Preliminary /
Final
Drainage
Report

Koinonia Ranch

Project No. 61148

SP-21-004

MVE PROJECT 61148
MVE DRAWING PP-DRN

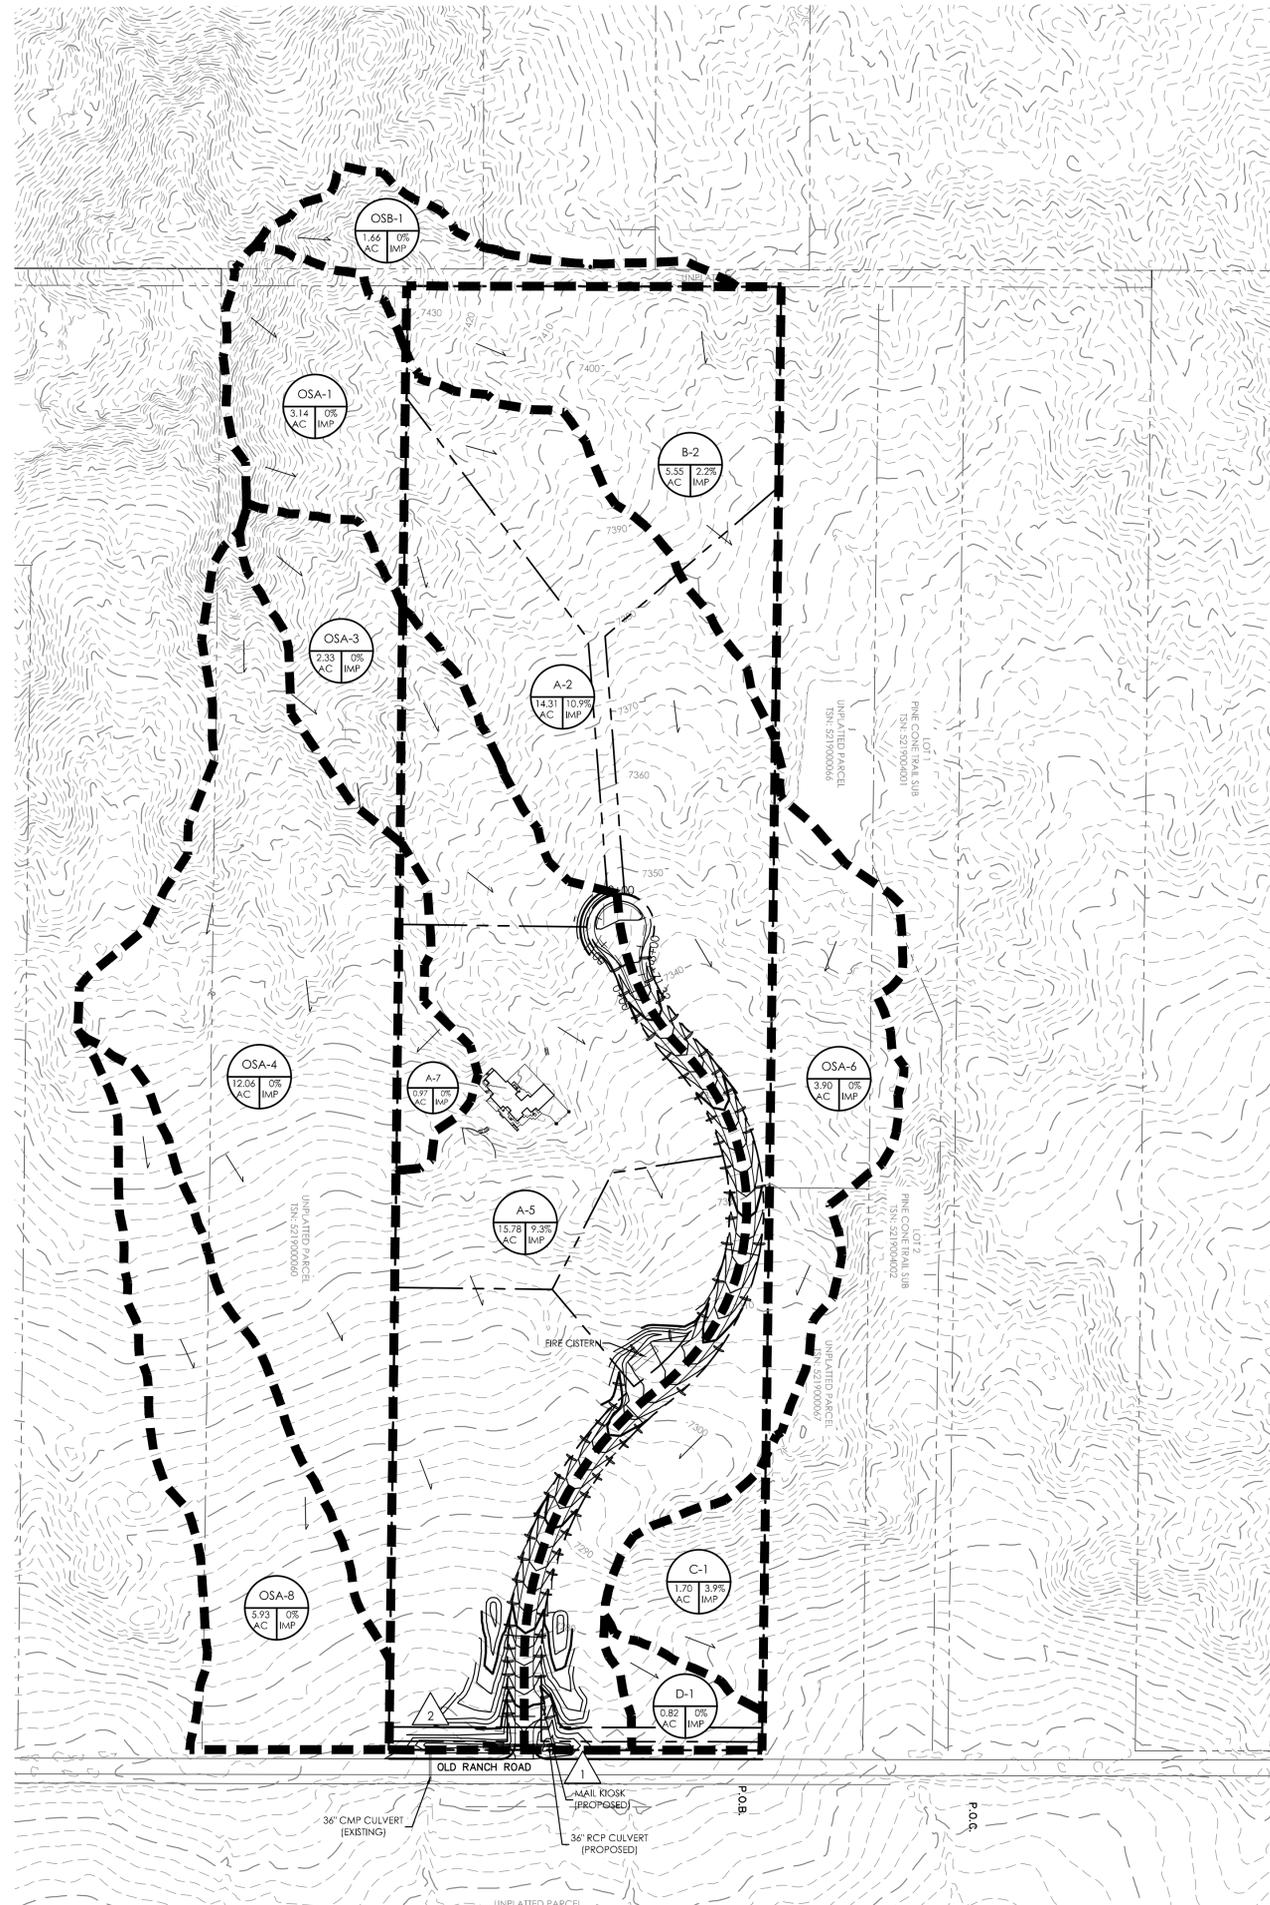
Please note, replacing the culvert under Old Ranch Road might be required since new development shall outfall into a suitable outfall. A culvert that is not functioning properly is not a suitable outfall. Other options can be explored, like providing detention for the site and controlling flows that outfall there. Detention should be required since increase of runoff is not negligible.

Please also note: providing detention for the development might prevent replacing the culvert downstream at design point 2. Additional discharge is not allowed when infrastructure is deficient.
